Addendum 5

December 2, 2022

SUCF 081058-00 Upgrade Elevators - Campus Wide at SUNY New Paltz, 1 Hawk Dr.
New Paltz, NY 12561

Prepared by MDSzerbaty Associates 307 Seventh Avenue, Suite 1501, New York, NY 10001 and
IAQ Systems Inc., 555 Eighth Avenue, Suite 1502, New York, NY 10018

1 LC BASEMENT POWER PART PLAN
SCALE: 3/8"=1'-0"

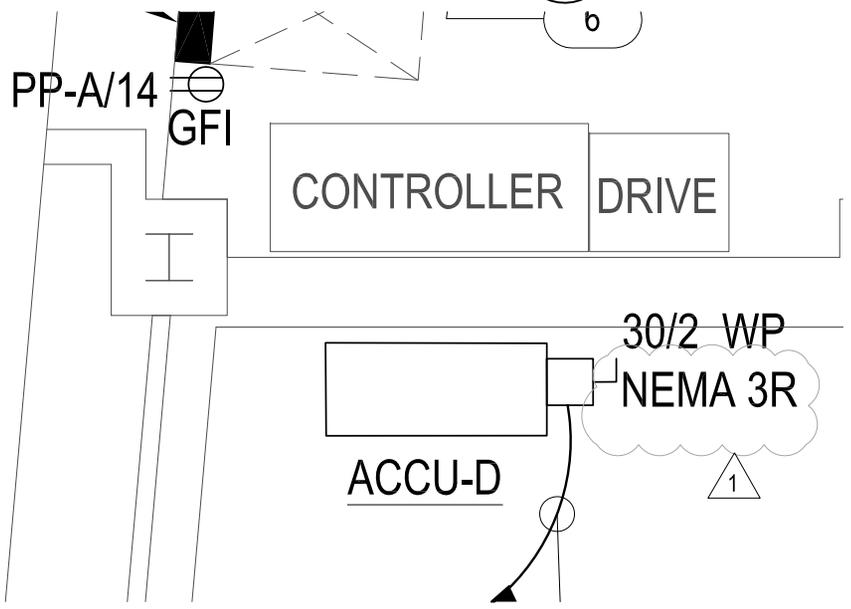
Revise drawing 1 as shown on drawing 1 on attachment 17.

Revise drawing 2 as shown on drawing 2 on attachment 17.

**STL GROUND FL ELEV#1
POWER PART PLAN**

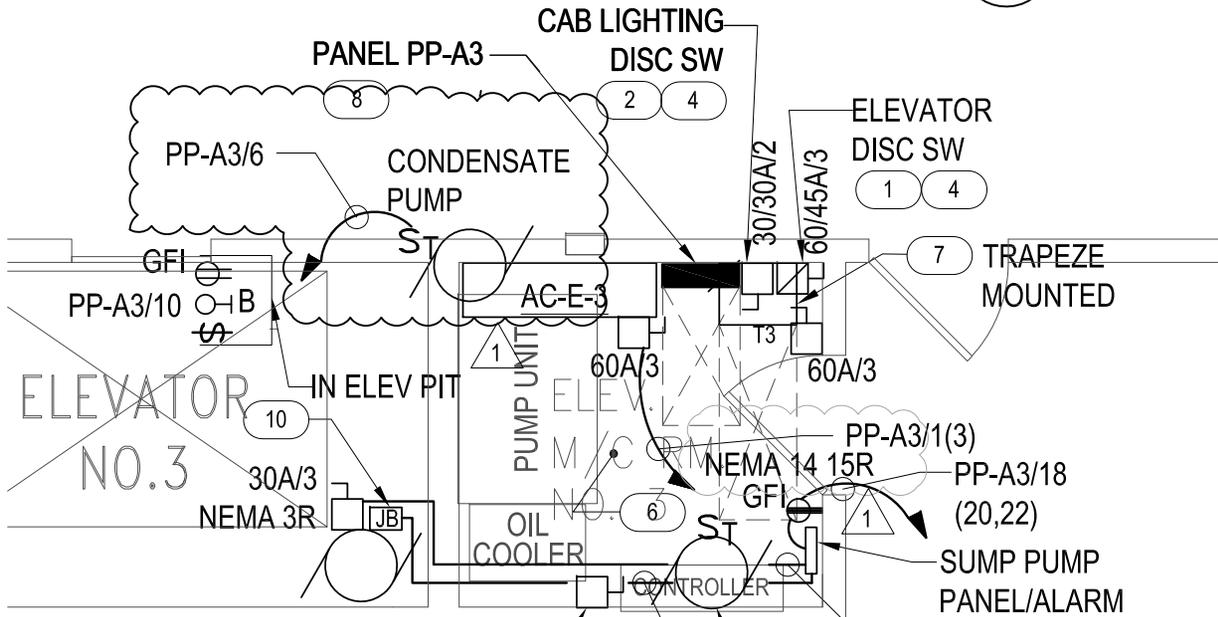
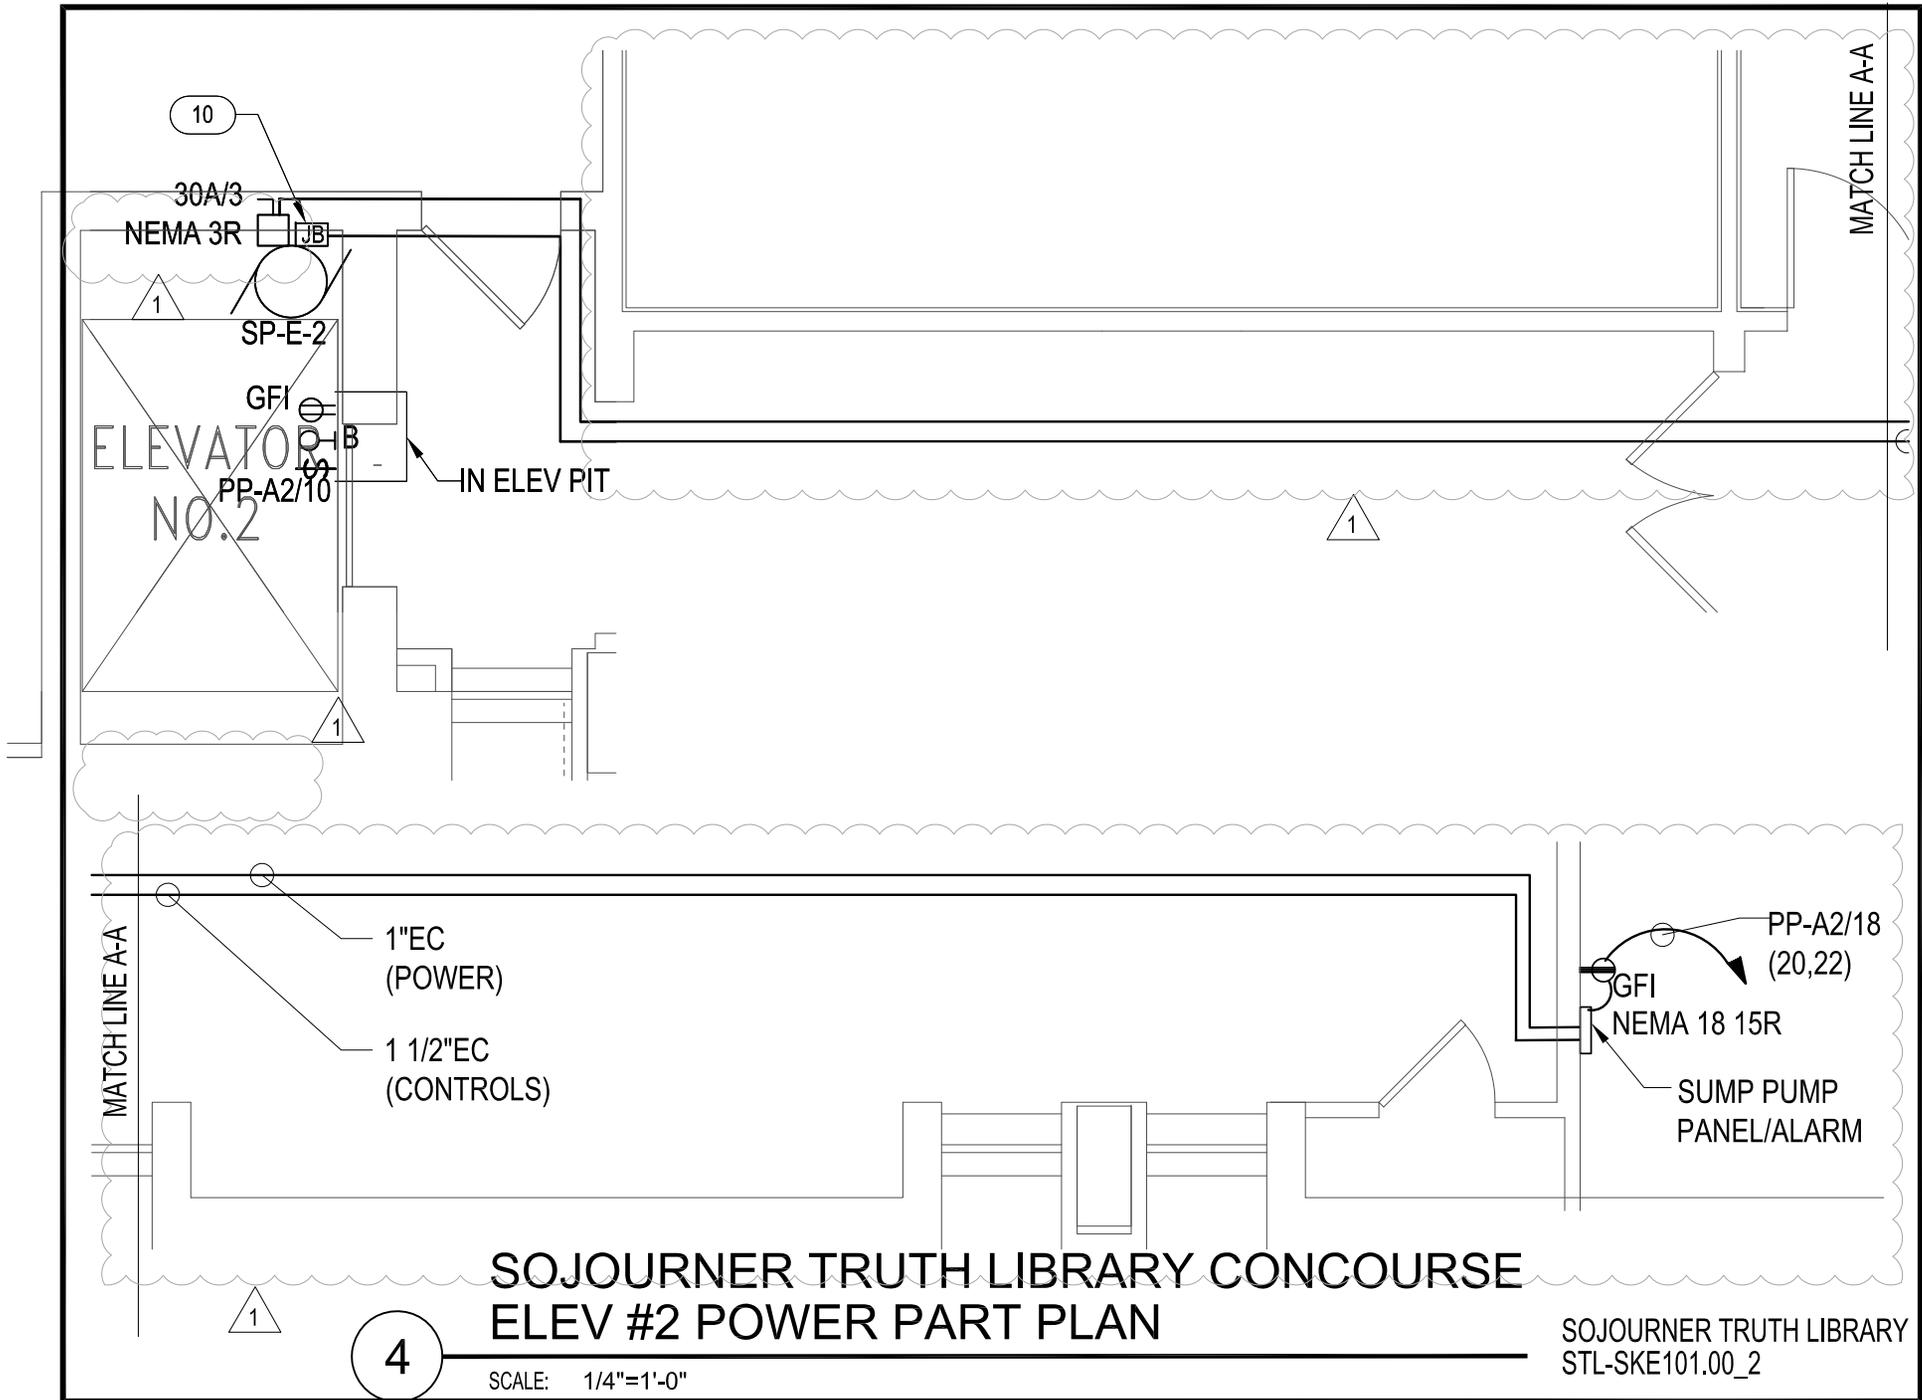
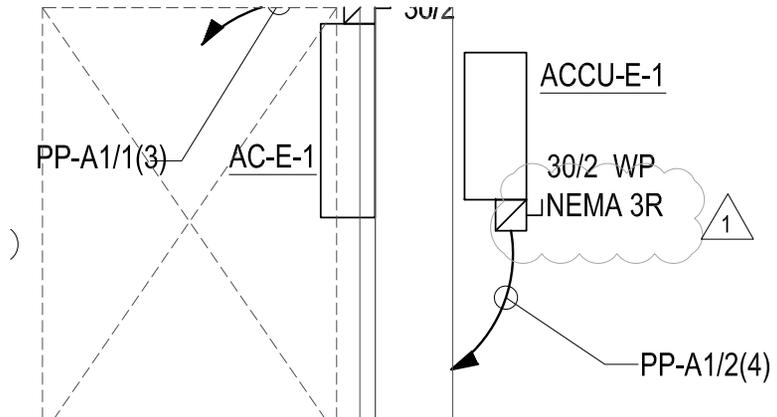
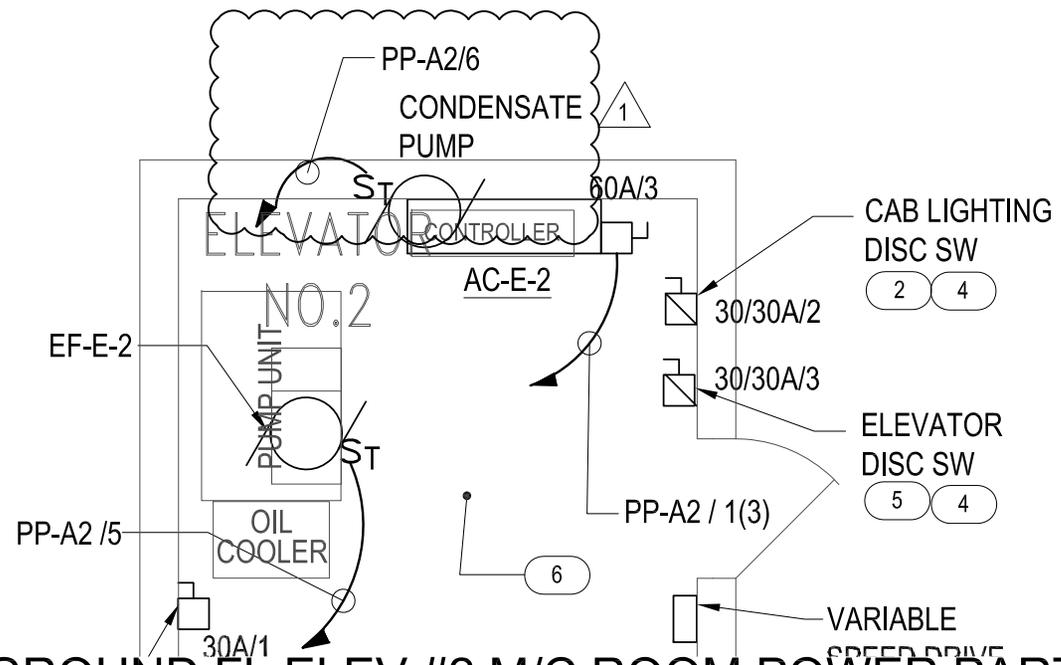
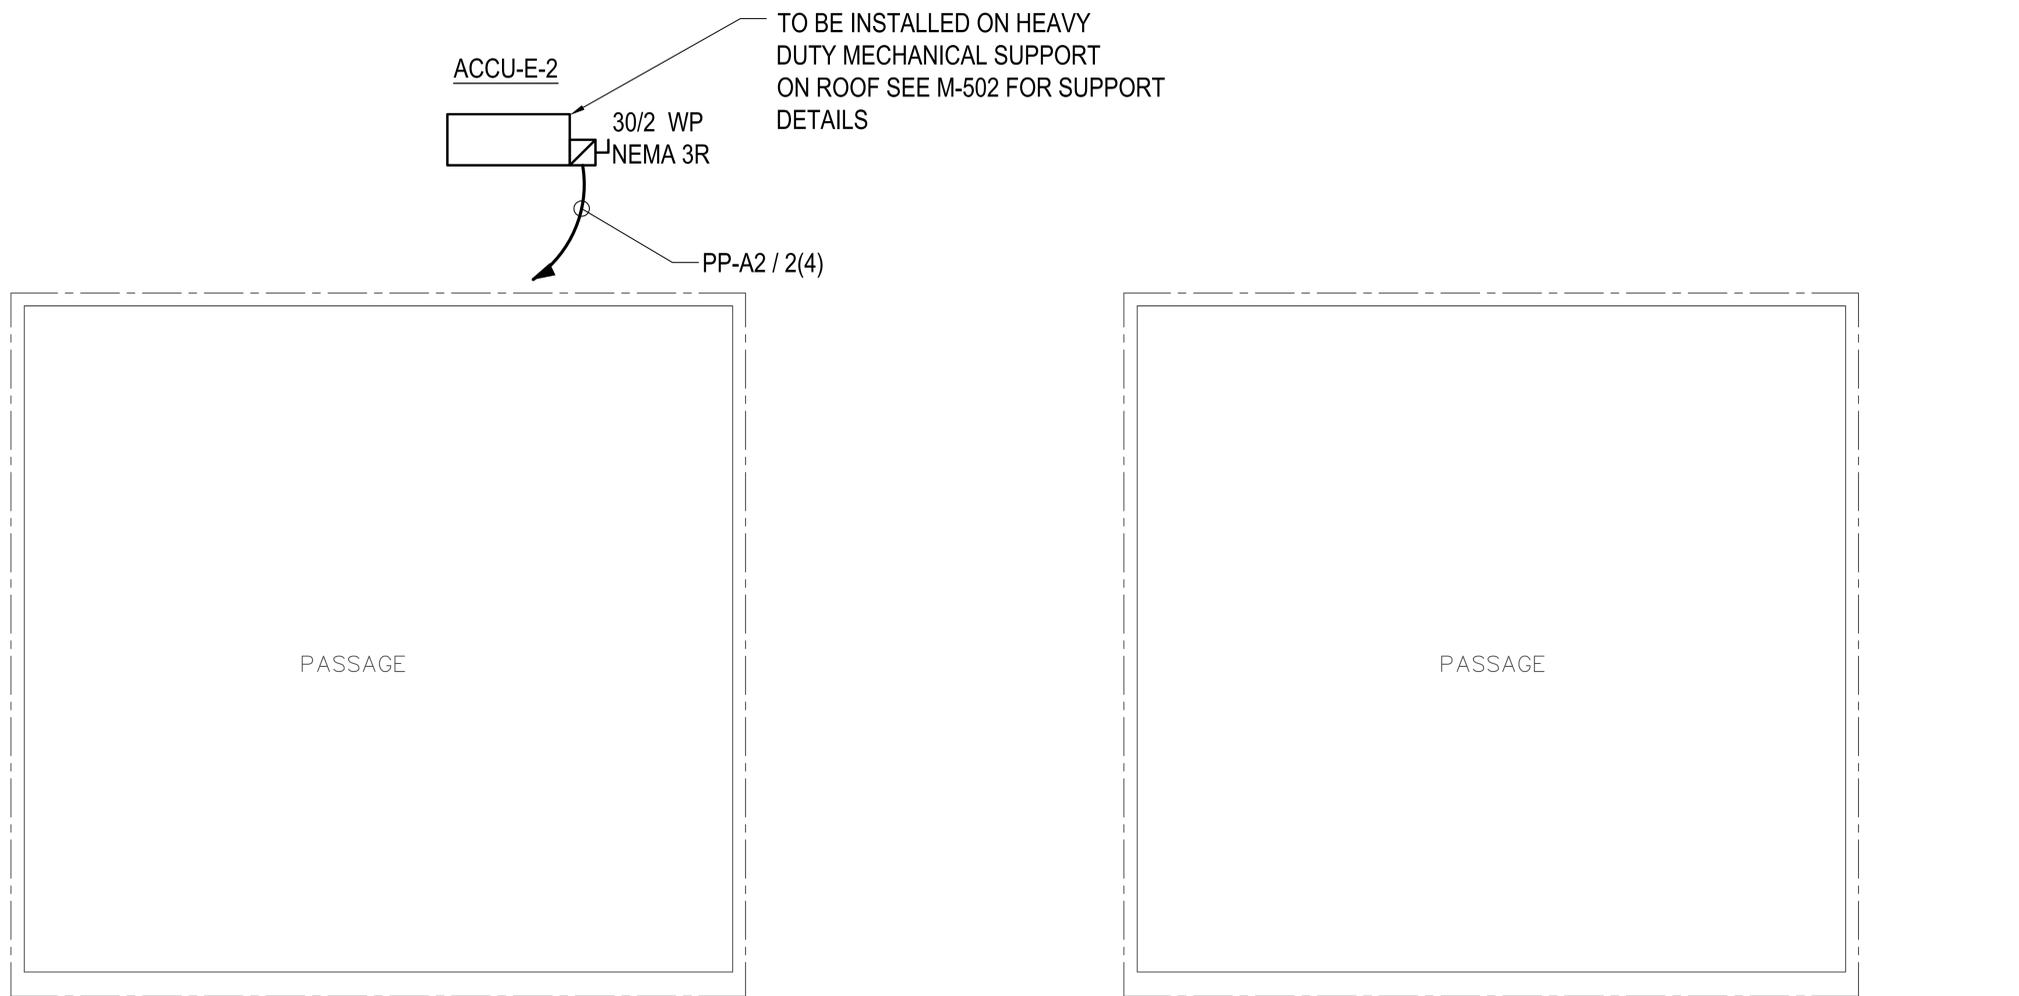
Revise drawing 1 as shown on drawing 1 on attachment 19

Revise drawing 7 as shown on drawing 7 on attachment 19

Revise drawing 4 as shown on attachment 20

Revise drawing 2 as shown on drawing 2 on attachment 21

Revise drawing 5 as shown on drawing 5 on attachment 21

Add drawing 1 on attachment 22

2 SUB PENTHOUSE POWER PART PLAN

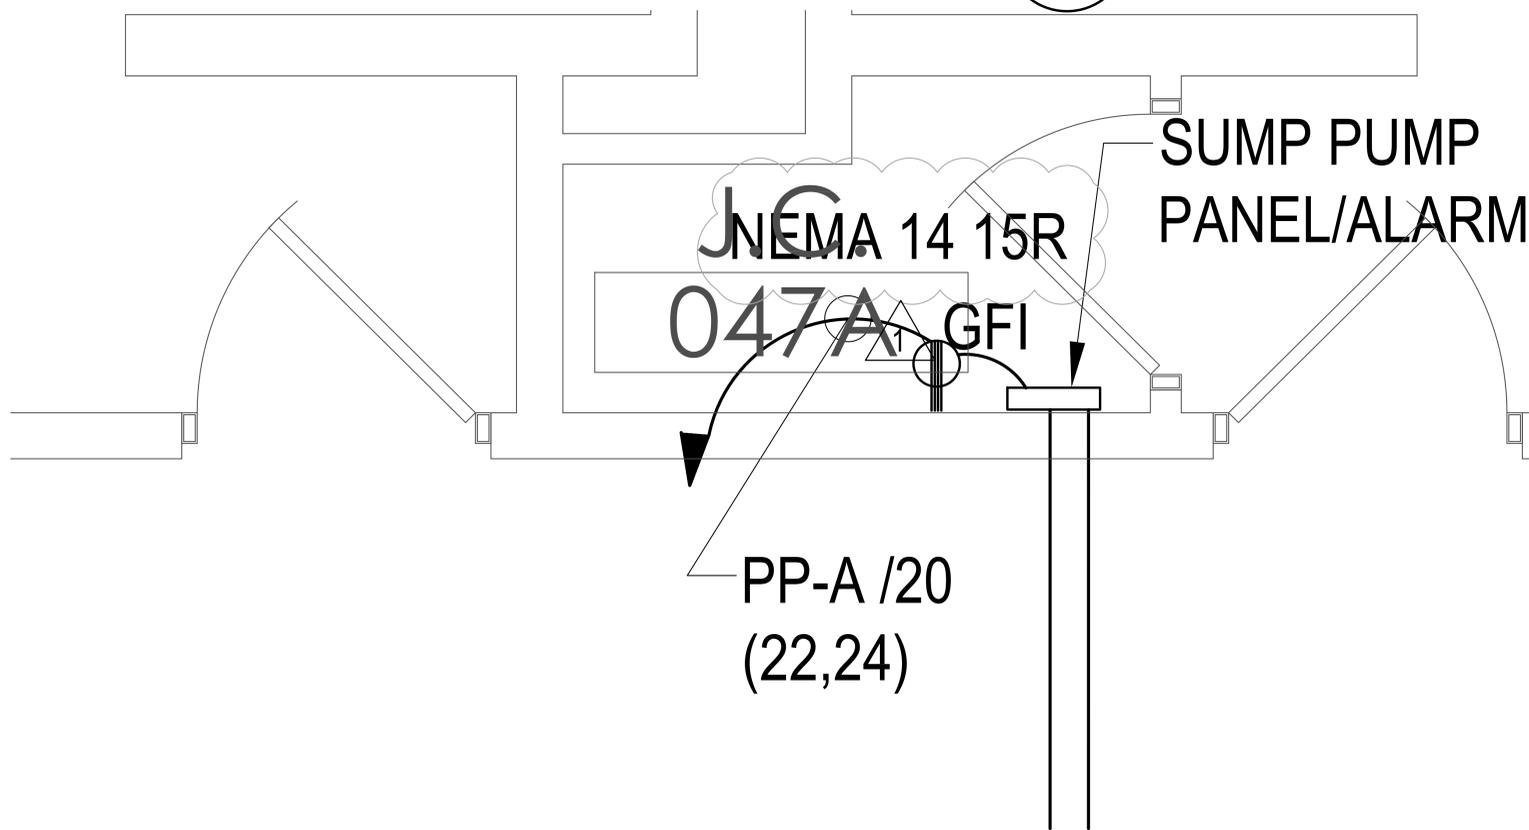
Revise drawing 1 as shown on drawing 1 on attachment 25

Revise drawing 2 as shown on drawing 2 on attachment 25

2
T004

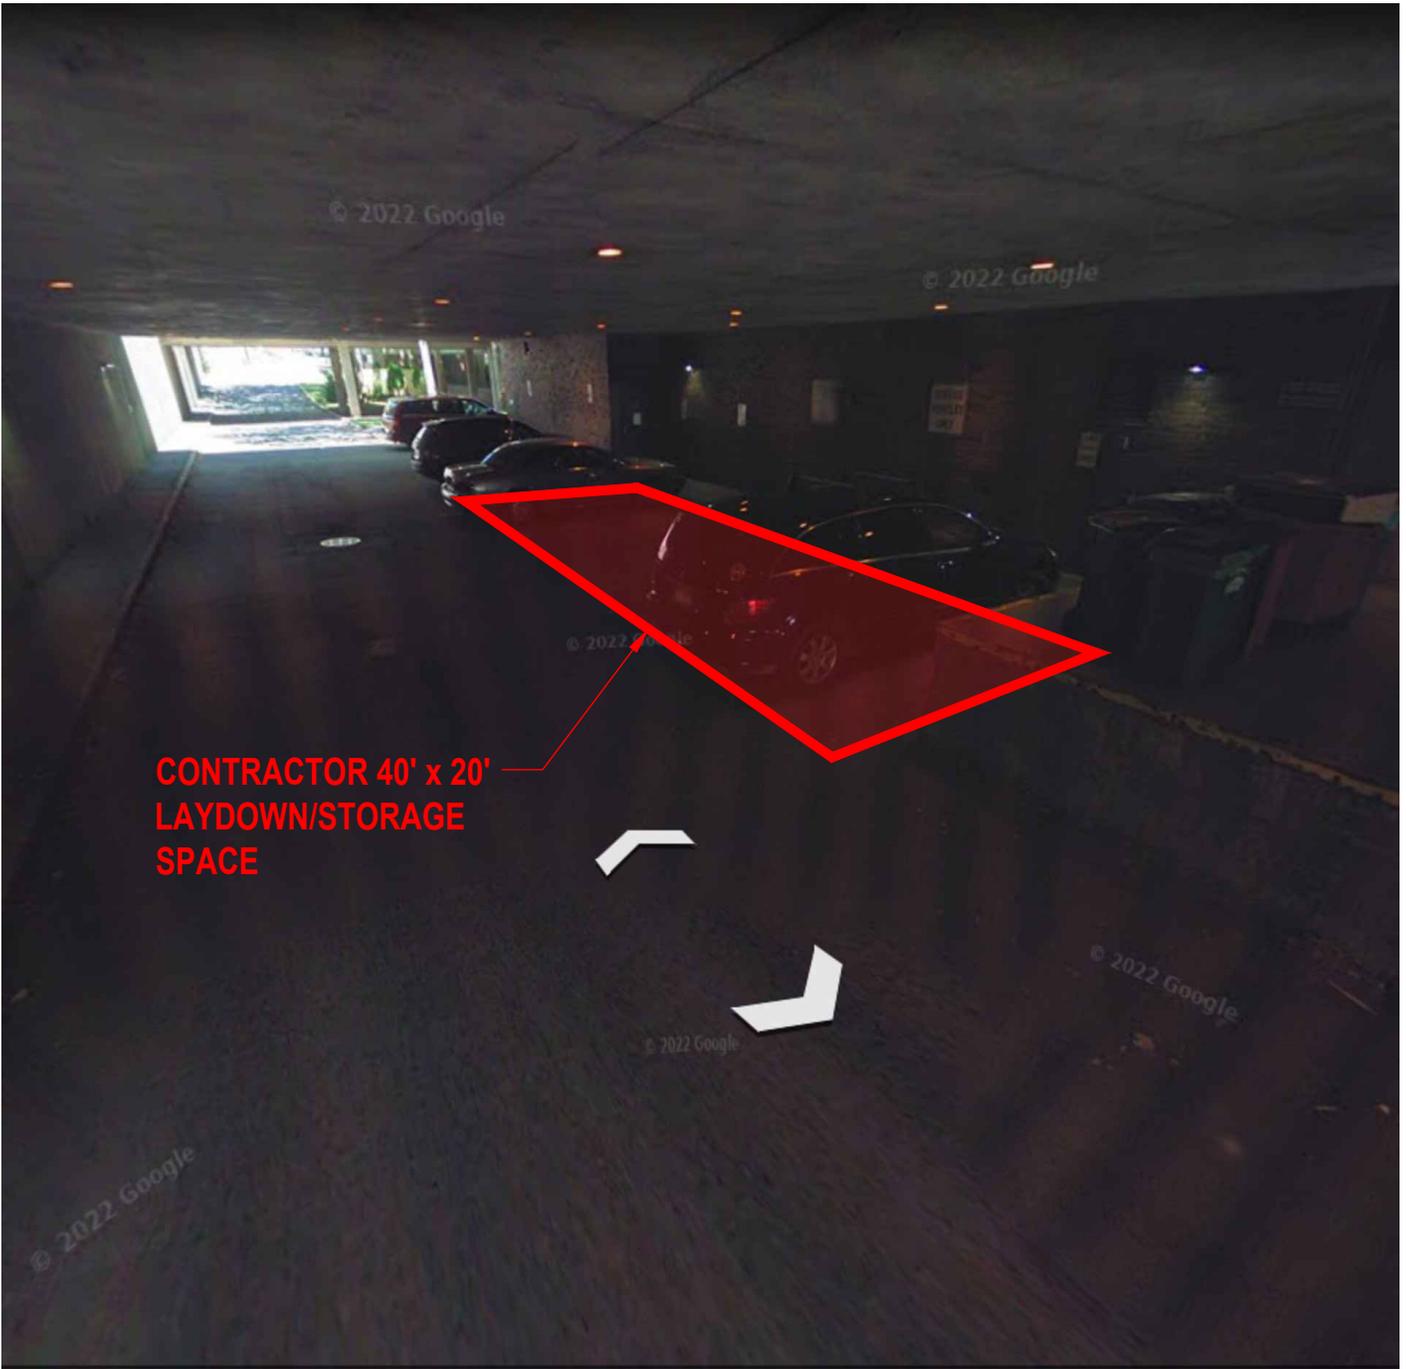
Replace drawing 2 with attachment 27.
